PMSTPCOL PEmails

We have prepared a detailed response to RAI 01.05-1, which requests evaluation of any impacts of the recently released seismic source characterization for the central and eastern U.S (CEUS-SSC) on the seismic design of Units 3 & 4. In short, we have found that the seismic design basis for Units 3&4 is not measurably impacted by CEUS-SSC. This email provides an executive summary of that work, whereas the details can be found in the attached RAI response.

RAI 01.05-1, Revision 1

Figure 4a. PGA total rock hazard curves from CEUS SSC (Figure 8.2-31) the STP 3 & 4 COLA, and the USGS (2008). See text for description.

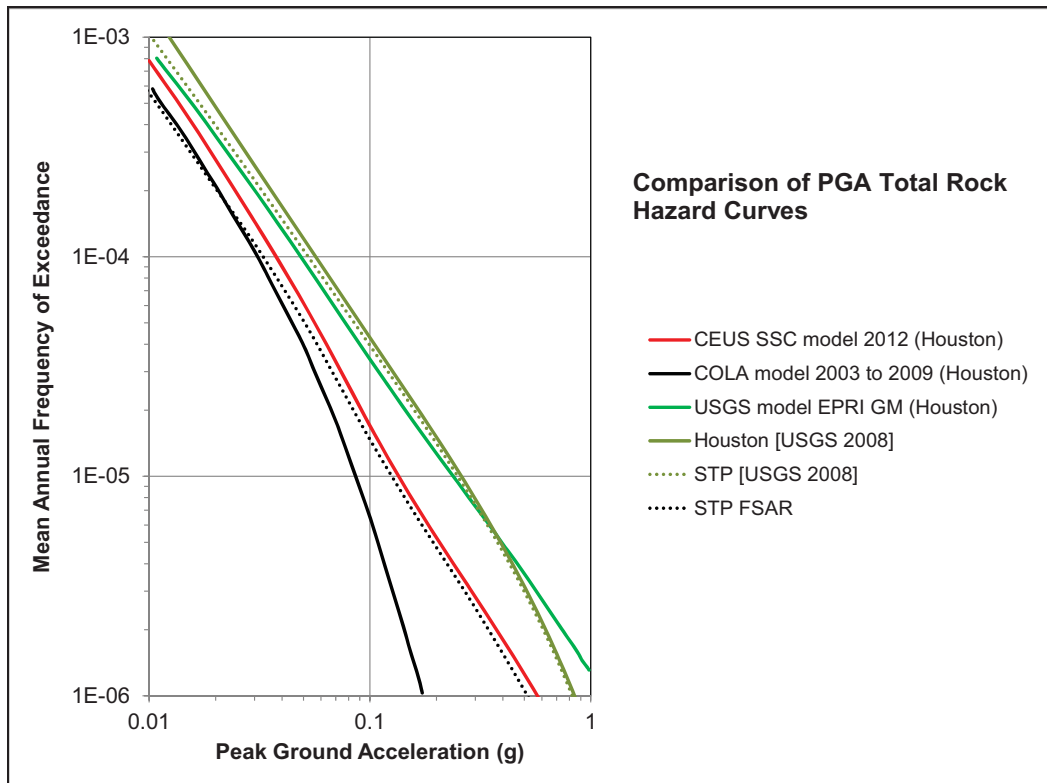
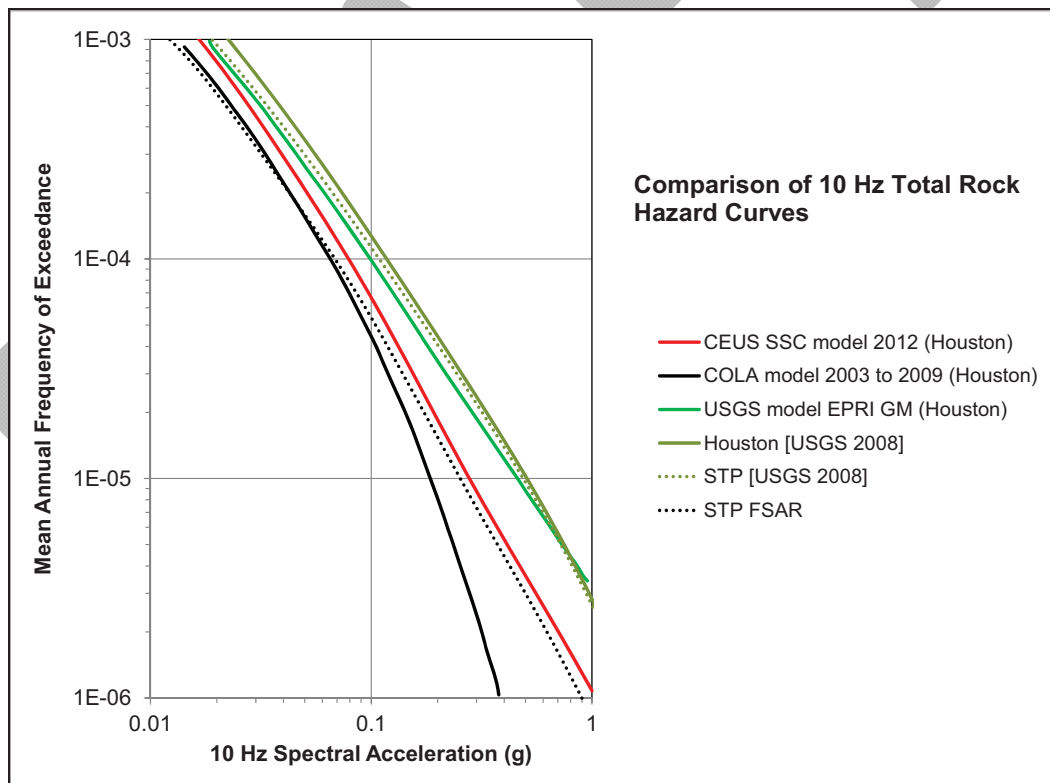
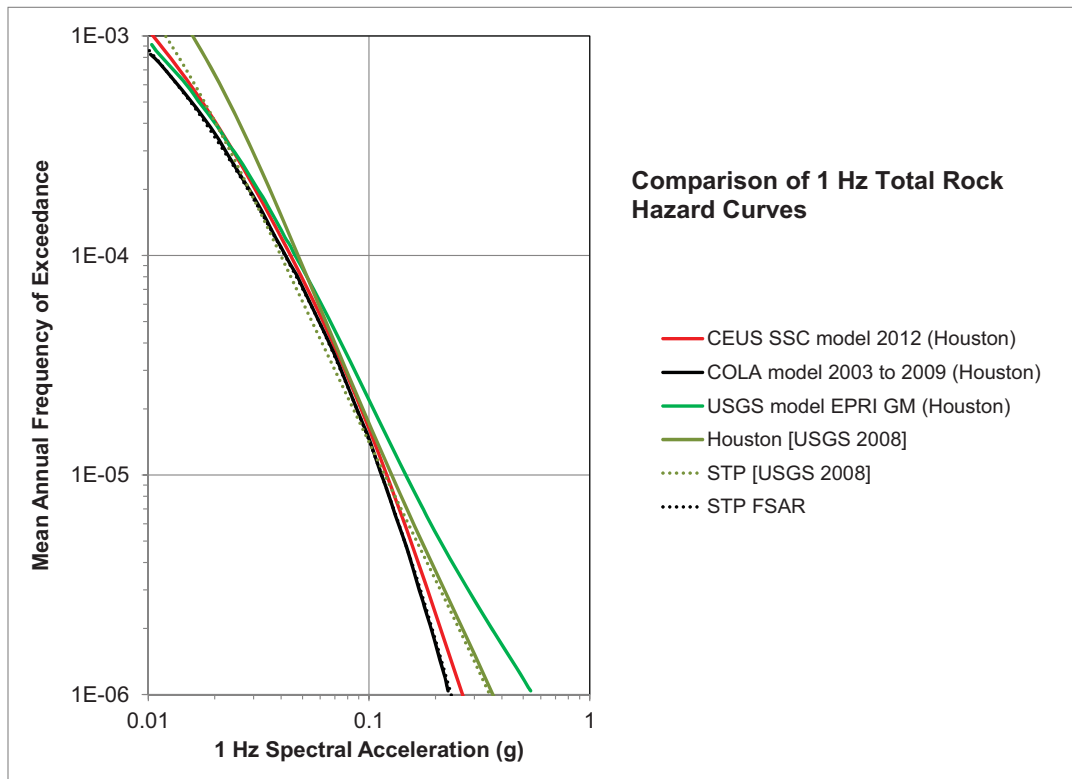
This request for additional information (RAI) specifically addresses Recommendation 2.1, of the Fukushima Near-Term Task Force recommendations contained in SECY-12-0025 as it pertains to the seismic hazard evaluation. This recommendation specifies the use of NUREG-2115, "Central and Eastern United States Seismic Source Characterization for Nuclear Facilities," (CEUS-SSC) in a site probabilistic seismic hazard analysis (PSHA). Consistent with Recommendation 2.1, as well as the need to consider the latest available information in the (PSHA) for South Texas Project Units 3 and 4 planned reactor site, the NRC staff requests that STP:

- a) Evaluate the potential impacts of the newly released CEUS-SSC model, with potential local and regional refinements as identified in the CEUS-SSC model, on the seismic hazard curves and the site-specific ground motion response spectra (GMRS)/foundation input response spectra (FIRS). For re-calculation of the PSHA, please follow either the cumulative absolute velocity (CAV) filter or minimum magnitude specifications outlined in Attachment 1 to Seismic Enclosure 1 of the March 12, 2012 letter "Request for information pursuant to Title 10 of the Code of Federal Regulations 50.54(f) regarding Recommendations 2.1.2.3, and 9.3, of the near-term task force review of insights from the Fukushima Dai-Ichi accident." (ML12053A340).
- b) Modify the site-specific GMRS and FIRS if you determine changes are necessary given the evaluation performed in part a) above.

A number of implications can be drawn from comparisons of these six hazard curves. First, the only intra-model [seismic source and GMPE] comparison – that of the USGS (2008) hazard curves for Houston and the STP site, shows that these curves are very close to one another, the STP curve falling slightly below the Houston curve for all PGAs. This agrees with arguments made above that hazard varies only very slowly between Houston and the STP site and that the hazard at STP would be expected to be slightly lower than at Houston given the slight decrease in a broadly smoothed regional activity rate tied to historical earthquakes (see Figures 2 and 3).

Differences between the solid green “USGS Model EPRI GM” and solid olive green USGS Houston curves reflect the effect of the different GMPEs used. Although larger than differences arising from the locations of Houston and STP these differences are still much less than the differences among the three CEUS SSC report curves. Since each of these three CEUS SSC report curves use the same GMPE characterization (and the same as is used for the STP Unit 3 & 4 COLA) their differences must arise from a combination of differences in their Gutenberg-Richter recurrence parameters and/or maximum magnitude distribution of contributing seismic sources.

The STP Units 3 & 4 rock hazard curves [dotted black] match the shape and have lower amplitudes than the Houston demonstration site rock hazard curves using the CEUS SSC model [solid red] over the three frequencies for which a direct comparison is available and for the entire range of ground motion accelerations investigated. All curves appear to match each other better as the ground motion frequency decreases, especially in the 10^{-4} and 10^{-5} MAFE range of greatest interest for GMRS development.
